SERVICE BULLETIN
SUMMARY

**TITLE: AIR CONDITIONING - AVIONICS EQUIPMENT VENTILATION -
UPGRADE TRU VENTILATION DUCT**

MODIFICATION CLASSIFICATION					
MAJOR	None				
MINOR	150334P11623

MODIFICATION No.: 150334P11623

Figure A-FSUAA - Sheet 01

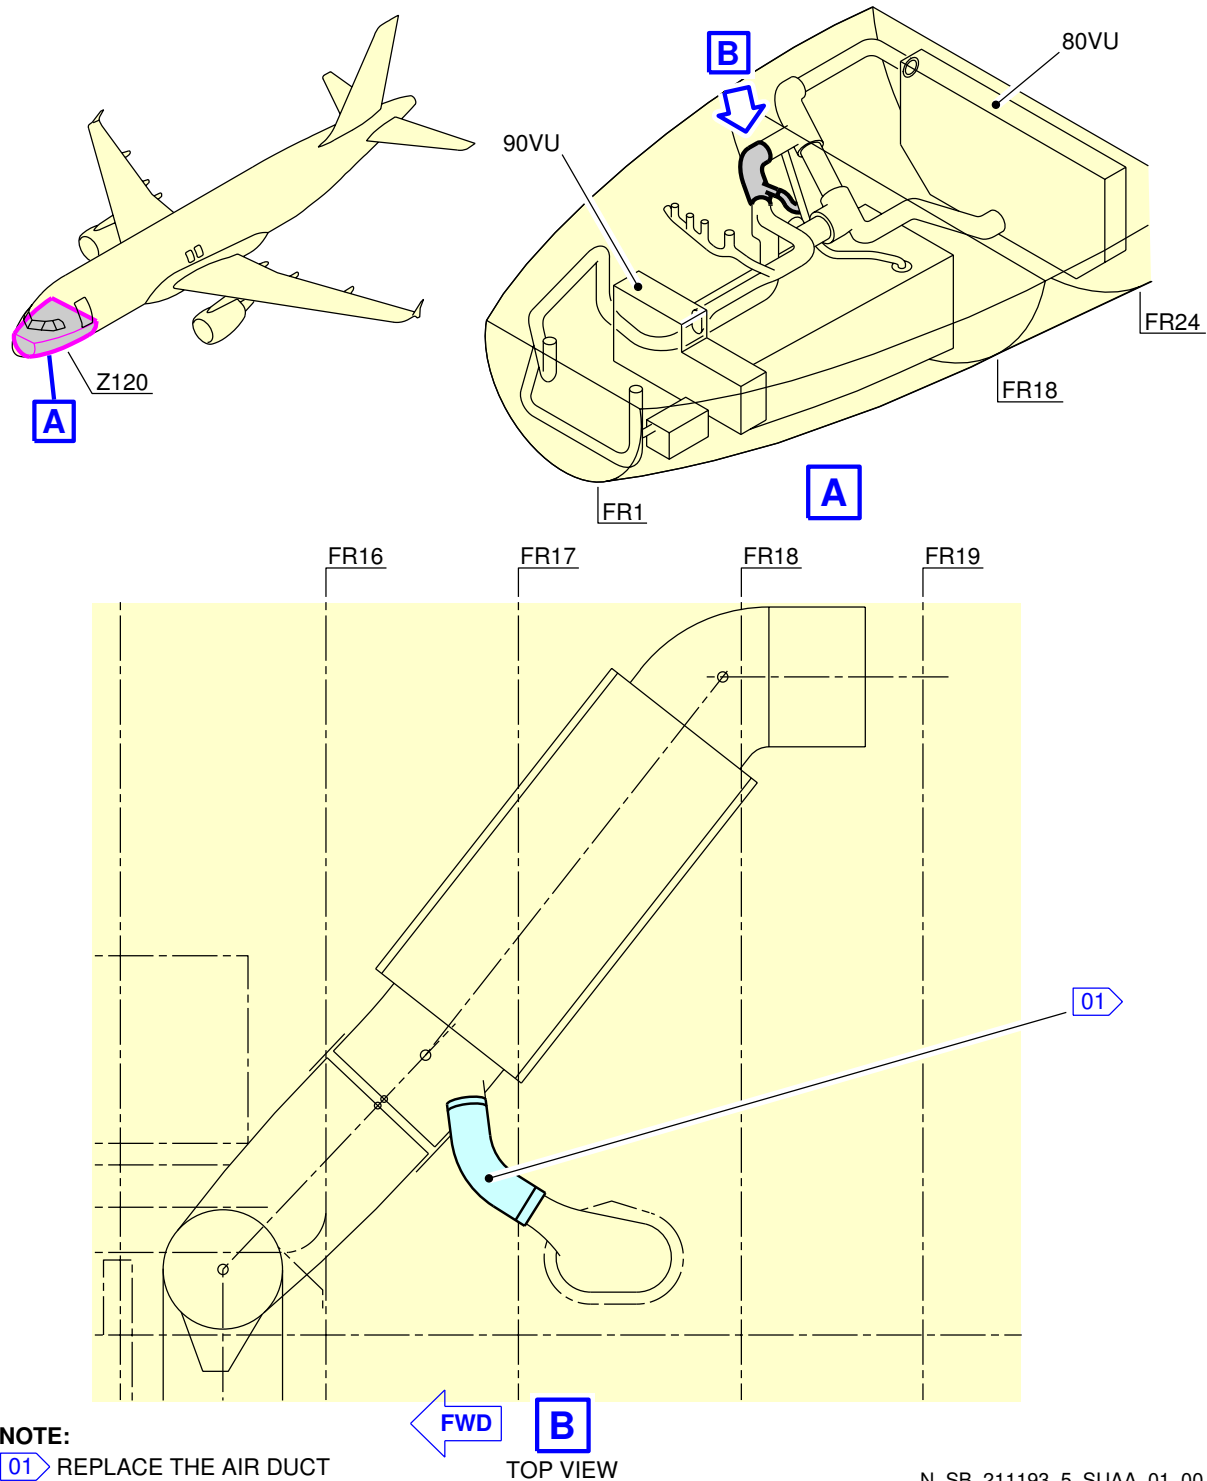
On aircraft post modification No. 37052P10052 (ELECTRICAL POWER - DC MAIN GENERATION - INTRODUCE AN ADDITIONAL TRU (4TH) TO COVER IFE NEEDS ON SINGLE AISLE CORPORATE JET), it has been highlighted that the hose located between the air extraction of the fourth Transformer Rectifier Unit (TRU) and the avionic air extraction pipe is too short.

This Service Bulletin proposes replacing the existing hose PN ABS1114B028D180 by new hose with PN ABS1114B028D210, 30mm longer.

Accomplishment of this Service Bulletin will allow to retrieve the correct shape of the installation.

Figure A-FBAAA - Sheet 01
Replacement of the Transformer Rectifier Unit (TRU) Ventilation Hose.

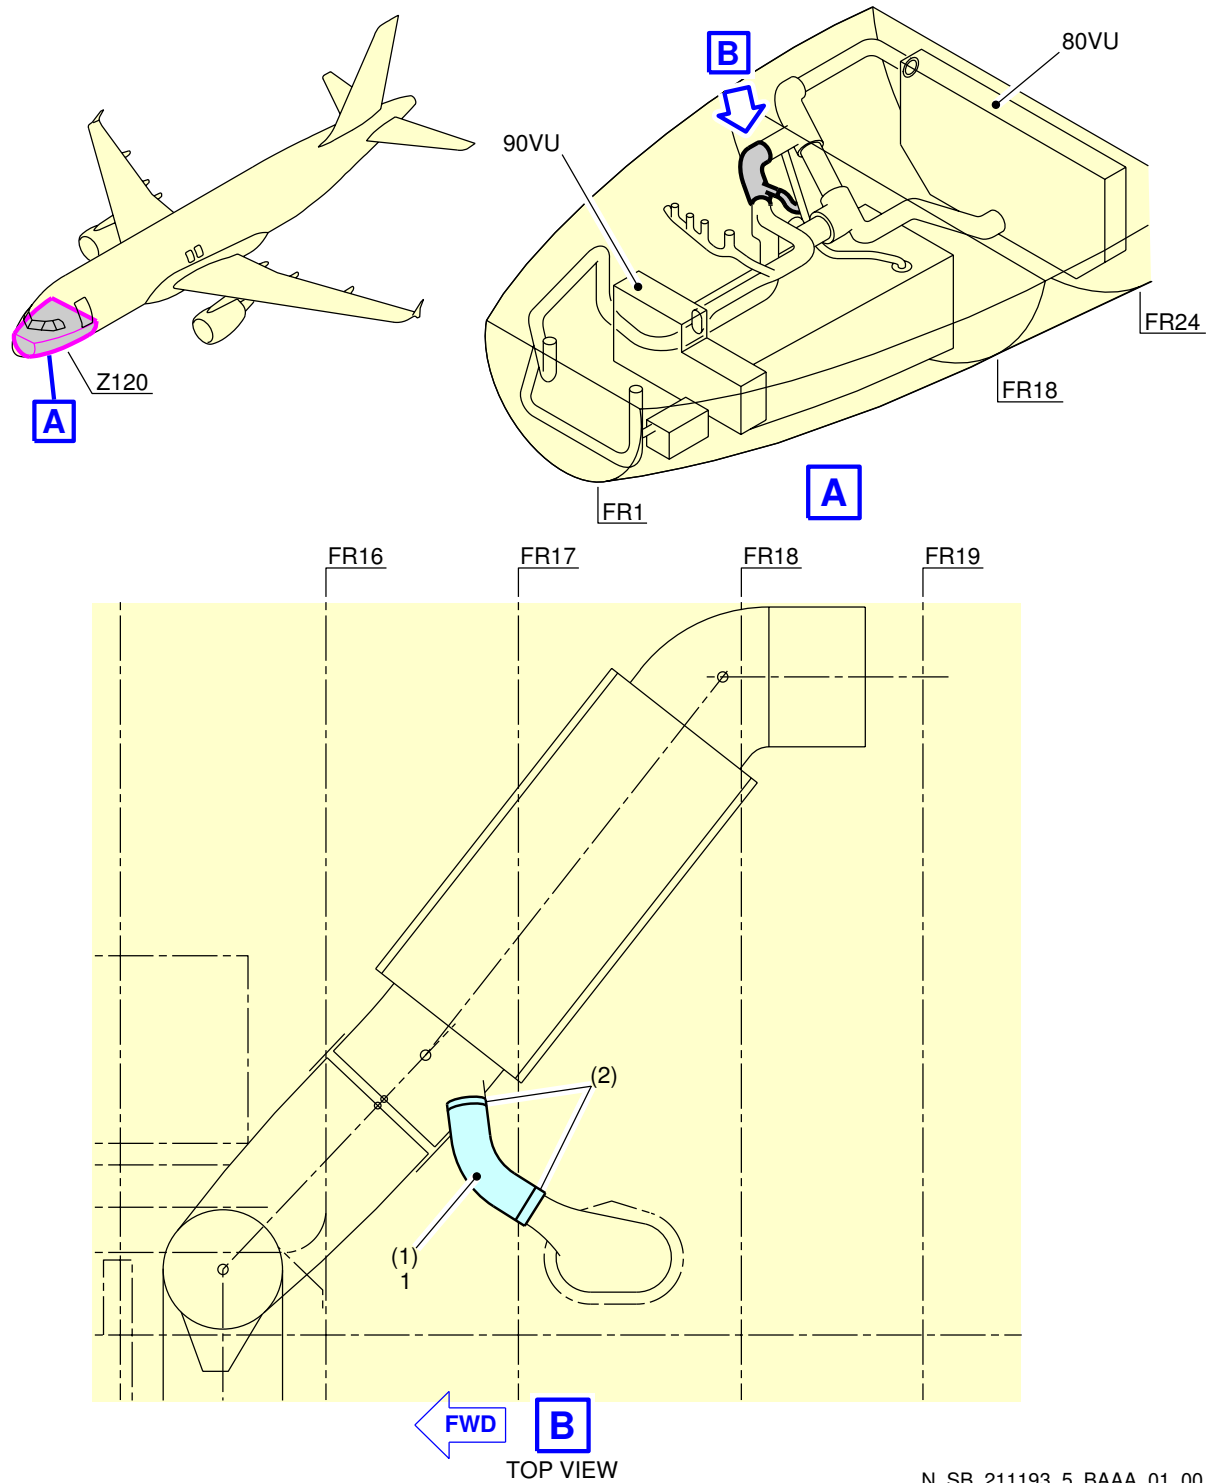
References	
Aircraft Maintenance Manual (AMM)	Task 21-26-41-000-002 Task 21-26-41-400-002
Fig. A-FBAAA	Sheet 01 - Replacement of the Transformer Rectifier Unit (TRU) Ventilation Hose.

- (a) Remove :

1	Hose	ABS1114B028D180 Item (1)	Discard
---	------	--------------------------	---------

(b) Install :

2	Clamp	Item (2)	Retained at removal
---	-------	----------	---------------------
